# SERVICE INFORMATION BULLETIN

SUBJECT: Service Manual Correction / DTC B281C

"Incompatible with EyeSight (EPS)"

Bulletin Number: 18-218-22; Date: 05/09/22

### DTC B281C INCOMPATIBLE WITH EyeSight (EPS)

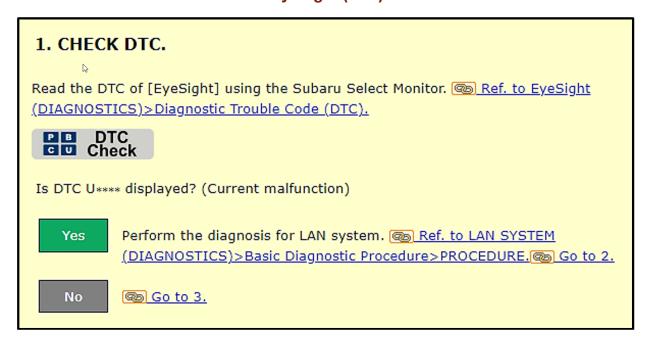
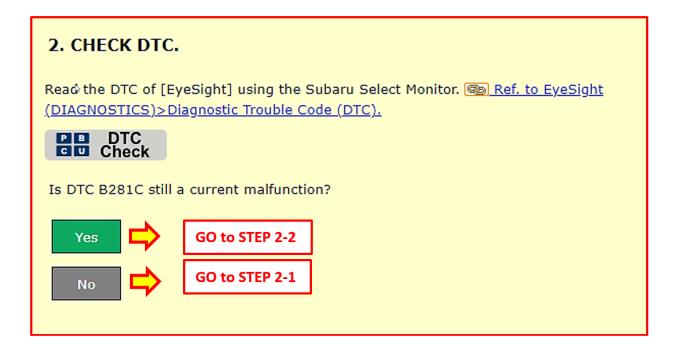
Refer to STIS: EyeSight (DIAGNOSTICS) > Diagnostic Procedure with Diagnostic Trouble Code (DTC) DTC B281C. The information below to be used in conjunction with the applicable Service Manual. The additional corrections have been outlined in RED.

#### 2-1 Checking EyeSight ECU power supply

Is the EyeSight ECU power supply voltage higher than 10V?

### 2-2 Checking Freeze Frame Data (FFD) for EyeSight ECU power supply

Read FFD and check EyeSight ECU power supply. If FFD is not available, go to

## Is the EyeSight ECU power supply voltage higher than 10V?

Using the Subaru Select Monitor, clear the EyeSight memory.

Check the battery voltage, electrolyte specific gravity, and electrolyte level. Recharge battery or replace battery. Using the Subaru Select Monitor, clear the memory of EyeSight.

Go to Step. 3 (The procedures for Step 3 and after continue to be unchanged)

Check the battery voltage, electrolyte specific gravity, and electrolyte level. Recharge battery and/or replace battery if needed. Using the Subaru Select Monitor, clear the EyeSight memory.
